Subject: 16V-364 Passenger's Front Airbag Module SIB 65 19 16

B65 19 16

This Service Information bulletin Replaces SI B65 19 16 **dated June 2016**

RECALL 16V-364: PASSENGER'S FRONT AIR BAG MODULE

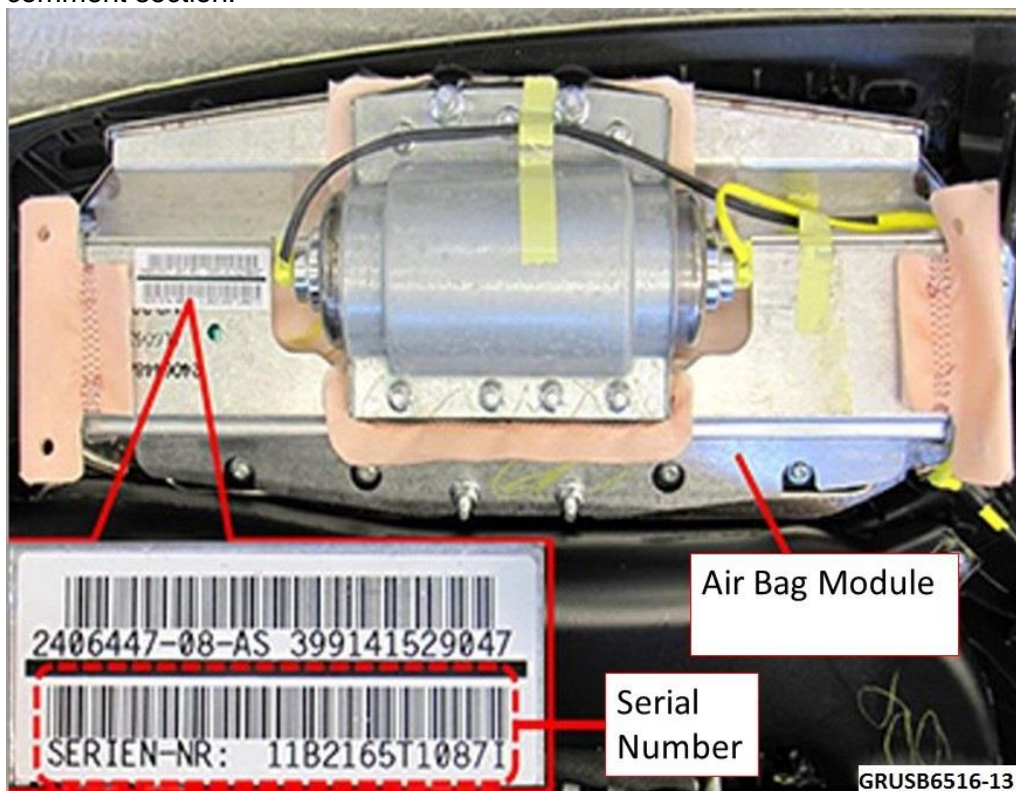
CORRECTION **UPDATE!**

Replace the passenger's front air bag assembly.
